- 3.1 This Statement of Common Ground (SCG) has been prepared by Brighton and Hove City Council (BHCC) together with National Highways.
- 3.2 BHCC is the local planning authority for the area, and has the main responsibility for coordinating development and change within the borough. National Highways is the responsible authority for the strategic road network (SRN). BHCC is also the highways authority for the remainder of the road network within the administrative area of Brighton and Hove.

3.4 BHCC has submitted its City Plan Part 2 (CPP2) for Examination in Public, with public hearing sessions expected to take place during November 2021; CPP2 is described further below and, once adopted, will become part of the development plan for the Brighton and Hove area alongside the adopted City Plan Part 1.

APPENDIX A: Proposed Mitigation Measures

Title
**Junction 3 - Carden Avenue
 Proposed Arrangement**

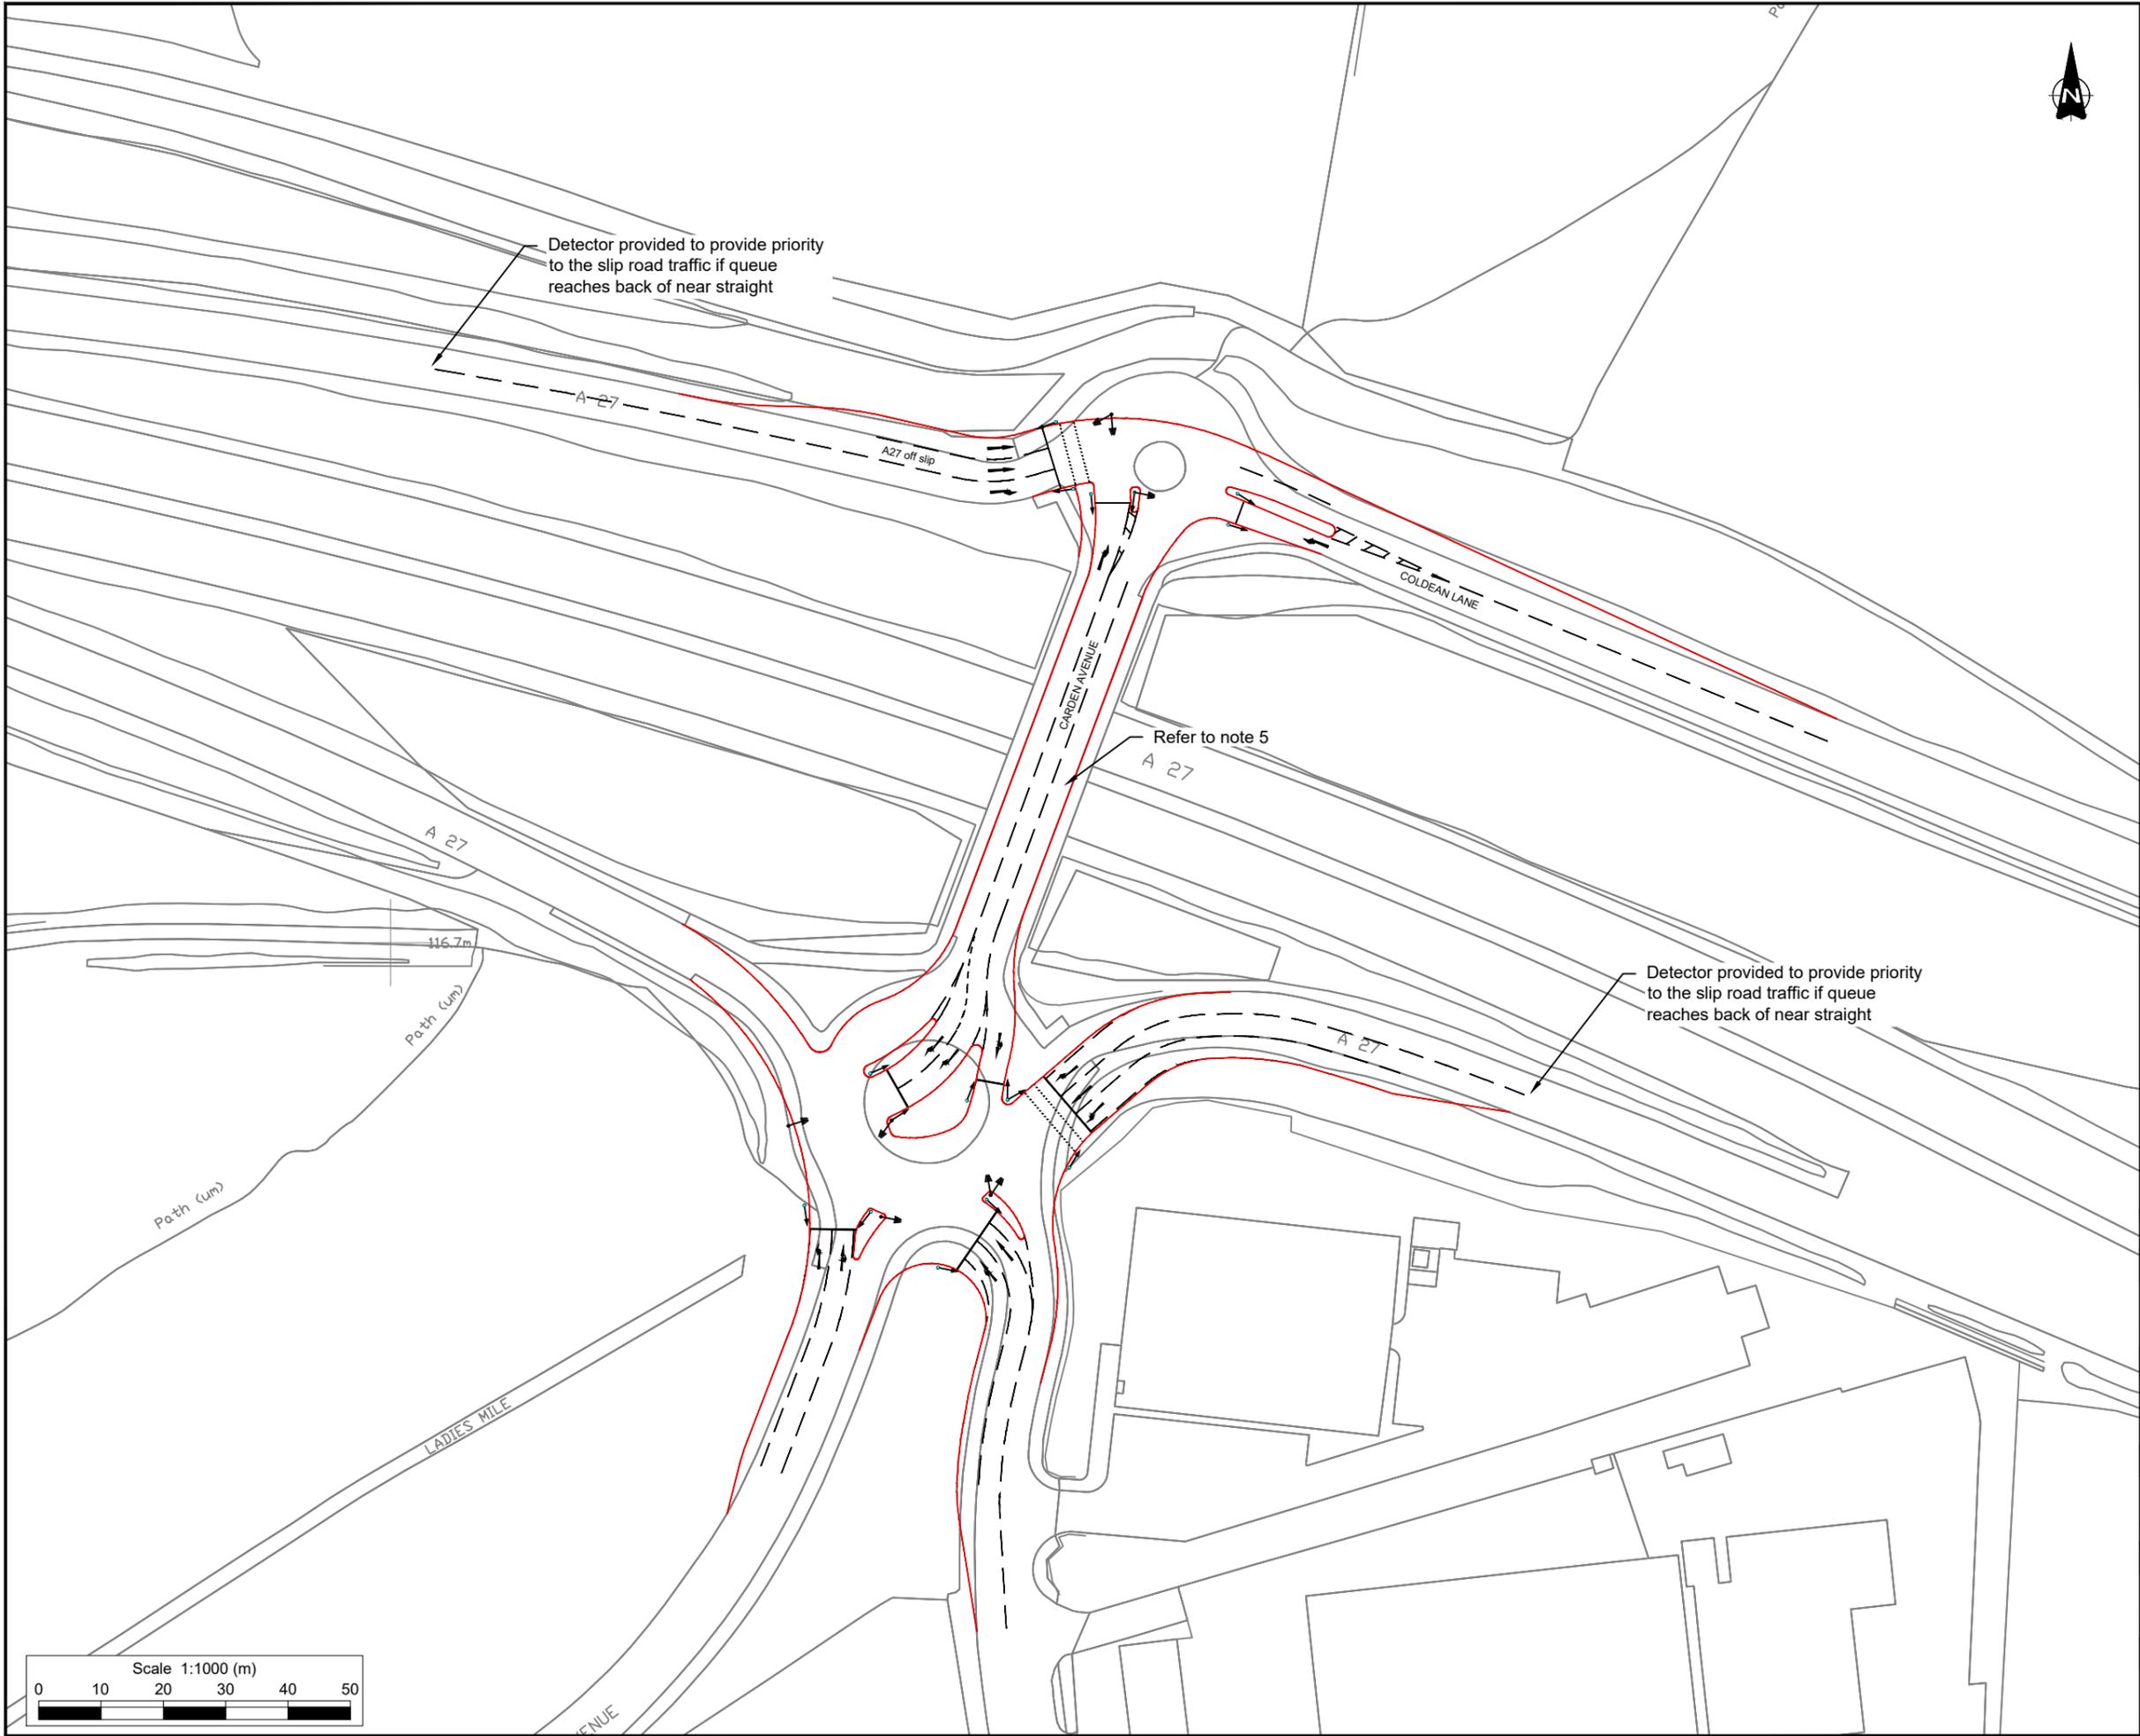
- Junction 3: Requested changes to lane lengths, use of cruise times instead of cruise speeds, and corresponding lane and flow assignments – SYSTRA noted that this would be expected to lead to a worsening of junction performance, but not sufficiently to render the proposed mitigation ineffective for its intended purpose.

Location	Overview of impacts identified
Junction 3 – A27 / Hollingbury Interchange	The 2030 reference case modelling indicates that there will be significant congestion affecting multiple arms of the junction on both its northern and southern sides, and that this includes queues which extend beyond the length of the A27 Eastbound off-slip, as well as queuing within the circulatory systems of the junction. Although CPP2 results in a relatively small absolute increase in vehicle trips at this location, the additional trips place further pressure on the A27 slips and the internal circulation; this requires mitigation to address a potential future worsening of safety concerns.
Junction 4 – A27 / A23	The 2030 reference case modelling indicates that there will be very significant congestion and queuing on both the A27 Eastbound off-slip and the A27 Westbound off-slip in the AM and PM peaks; these queues would be expected to potentially extend beyond the available safe storage of the slip roads. The CPP2 development adds to demand on these arms as well as elsewhere in the junction and it is therefore agreed that mitigation of these impacts is required.

- 8.5 The drawing of the proposed junction mitigation scheme for the Hollingbury Interchange is included in Appendix A as drawing reference 109418-dwg-04_A2 (J3 Carden Avenue).

- 8.6 The mitigation proposals include provision of a third lane on the approach to the southern part of the junction from the A27 Westbound off-slip, re-provision of the pedestrian crossing across the A27 Westbound off-slip, and introduction of detector loops on the A27 off-slips to allow the signal system to react directly to the formation of any queues which are approaching the ends of the available off-slip storage.

- 8.7 The modelling of this proposed scheme indicates that both the off-slips and the internal circulation of the junction will be improved, with DoS and queue lengths both reduced, so that the risks of safety impacts to the main line of the A27 are avoided. It is recognised that at the busiest periods this is likely to lead to a substantial increase in queues and delay on Crowhurst Road (particularly the PM peak); however, the introduction of the detector loops will enable the signal system to maximise the total through-put of the junction except in those specific circumstances where the queues on the off-slips become sufficiently long to require immediate priority. It is considered by BHCC and National Highways that this provides the greatest overall capacity at the junction whilst also assuring that safety issues with the slip road queues do not occur in practice, and that as such the proposed mitigation is appropriate given the limited “absolute” impact in terms of additional vehicle trips directly attributable to CPP2.

Title
**Junction 4 - Patcham Interchange
Proposed Arrangement**

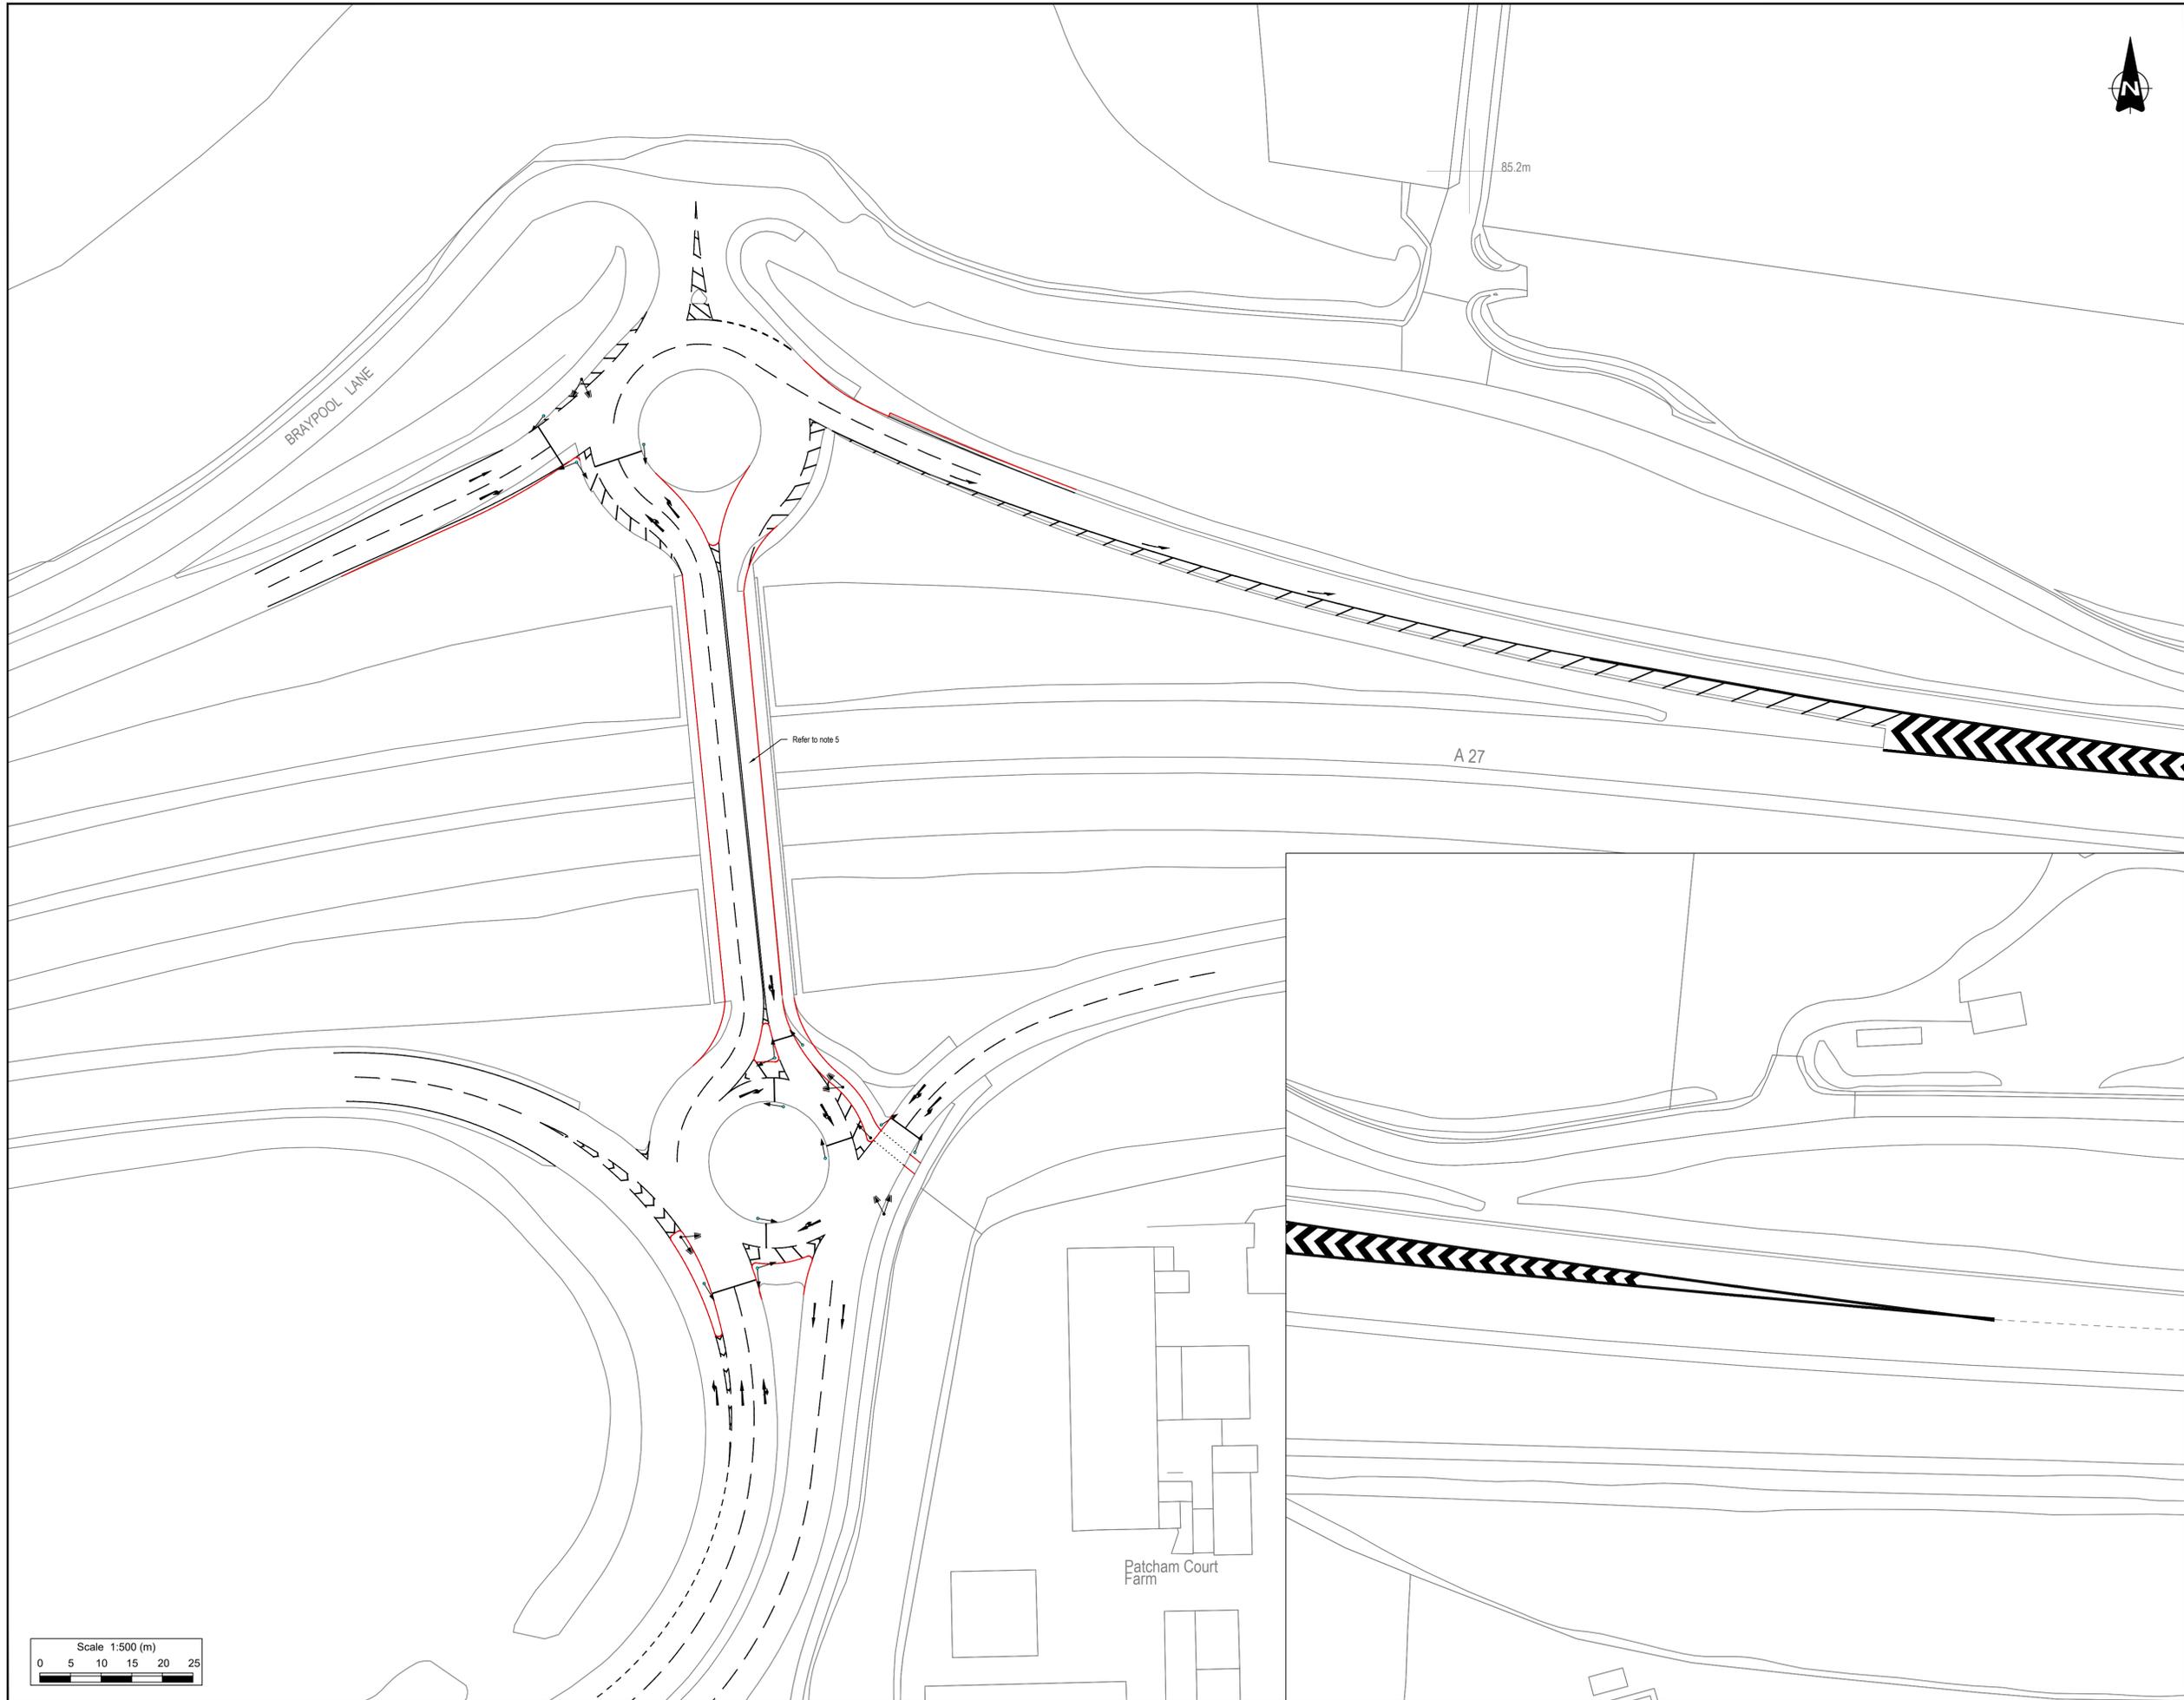
- Junction 4: Northern junction requested to be modelled as a signalised roundabout, rather than a crossroads; amendments requested to lane lengths, lane connectors, intergreen times and the inclusion of U-turning traffic – SYSTRA response noted that the small size of the roundabout and the limited availability of stacking space was correctly representing constraints at the junction, and that other proposed changes would have minor impacts to the overall model performance.

- 8.8 The drawing of the proposed junction mitigation scheme for Junction 4 is included in Appendix A as drawing reference 109418-dwg-01_A2 (J4 Patcham Interchange).
- 8.9 The proposed mitigation includes minor adjustments to the junction geometries and widening of the westbound A27 off-slip to provide two lanes at the junction.
- 8.10 The proposed mitigation scheme results in very significant improvements from the 2030 reference case, reducing the DoS of the off-slips from well over 100% to below 90% in all time periods and bringing queues well within the capacities of the off-slips and internal circulatory. All other arms of the junction also perform at below 90% DoS.
